**Japan's Opinion for the R129 Phase 2
and
Correction of an Editorial Error in the
Draft of Phase 2**

41st GRSP Informal Group on Child Restraint System

6th Nov. 2013

JASIC

Japan's Opinion on the CRF of the Booster Seat

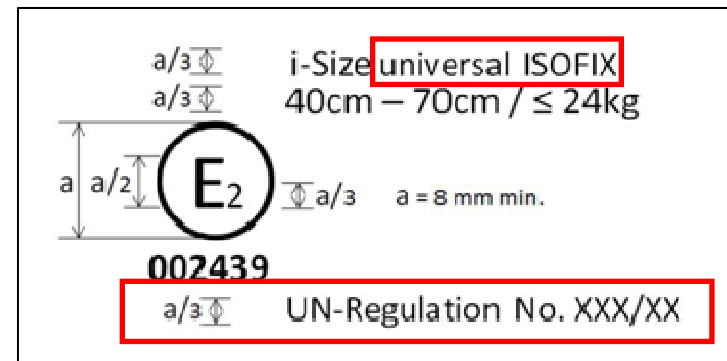
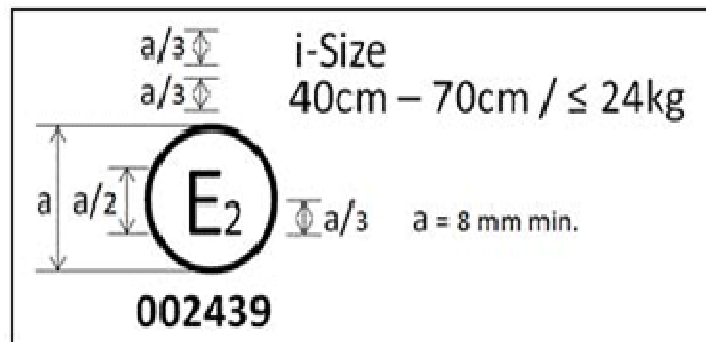
- The size of the non-ISOFIX universal booster seat is defined as same as the R44 requirements (UN/R44 6.1.8, 6.1.9 and 6.2.7).
- The new CRF is used only for the ISOFIX booster seat.

- We are concerned that if only the booster seats in conformity with the CRF size that is currently being discussed were considered “universal”, those high back booster seats in size ranges 140 cm or above would have to be manufactured only as “specific” CRS.
- In this case, all the high back booster seats in size ranges above 140 cm would be considered “specific, and therefore it would become difficult for CRS manufactures to product and sell them all over the world. Consequently, these high back booster seats would not be widely used and the child occupant safety would not be improved.
